SUBJECT:
Perry Nuclear Power Plant
Docket No. 50-440, License No. NPF-58
License Amendment Request to Modify Technical Specification 2.1.1, "Reactor Core SLs," to Incorporate Revised Safety Limit Minimum Critical Power Ratio Values

Subject: License Amendment Request to incorporate revised safety limit minimum critical power ratio values as a result of a site-specific fuel cycle analysis.

GNF Additional Information Regarding the Requested Changes to the Technical Specification SLMCPR

Perry Cycle 14

Figure 1. Current Cycle Core Loading Diagram

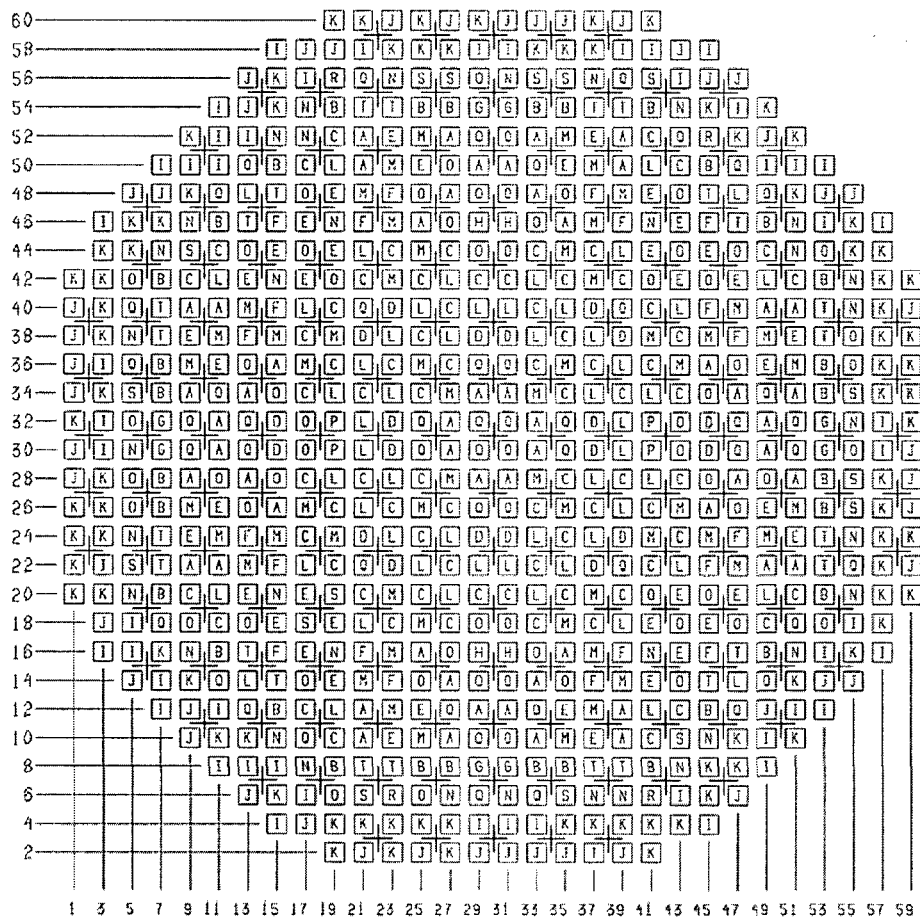
Figures 1 and 2 provide the core-loading diagram for the current and previous cycle respectively, which are the Reference Loading Pattern as defined by NEDE-24011-P-A. Table 1 provides a description of the core.
